**PROPOSED S278 SIGNALISED
JUNCTION SCHEME,
NEW GOETRE PRIMARY SCHOOL,
MERTHYR TYDFIL**

**STAGE 1/2 - ROAD SAFETY AUDIT
JULY 2025**

Figure 1: Scope of highways works subject to RSA.

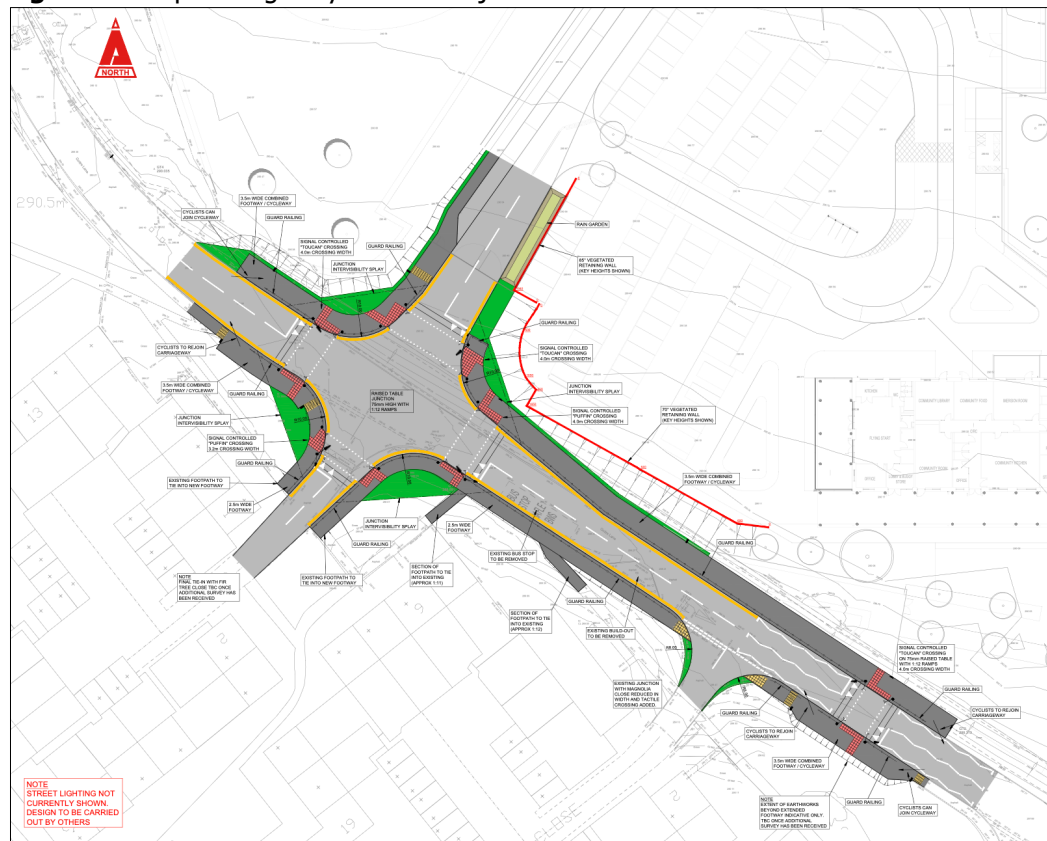
- 2.1 It is unclear how it is intended cyclists will access or leave the shared use route where it starts/terminates at various locations throughout the scheme including but not limited to the following examples; if travelling southwest bound on the site access arm of the junction, if entering the school where the shared use route terminates on the north-western side of the site access arm and if travelling on bike from Fir Tree Close or Magnolia Close.

- 2.2 The audit team also note the proposed use of 'cyclist dismount' signs at a number of locations although would note that typically cyclists do not adhere to this instruction and the use of the signs is not considered to be good practice.

- 2.3 Omission of suitable transition arrangements for cyclists at the start/end of the shared use route could result in cyclists having to negotiate full height kerbs increasing the risk of fall hazards or injudicious entry manoeuvres into the carriageway at unsuitable locations increasing the risk of cyclist/vehicle collisions.

- 2.8 The scheme drawings do not indicate any lane carriageway markings to advise drivers turning right from both the Goitre Road arms of the junction where to position their vehicle if held up in the centre of the junction by opposing vehicle movements. Omission of advisory carriageway markings could potentially increase the risk of head-on type collisions.

- 2.4 It is recommended that appropriate transition arrangements e.g. cycle on/off slips be provided to allow cyclists to enter/leave the carriageway where the shared use route terminates and include advisory carriageway markings to advise cyclists/drivers where the cycle on/off slips are located.
- 2.5 It is also recommended that the scheme include provision for cyclists to access the shared use route from Fir Tree Close or Magnolia Close

- 2.9 It is recommended that appropriate lane guidance carriageway markings be provided to address this problem.
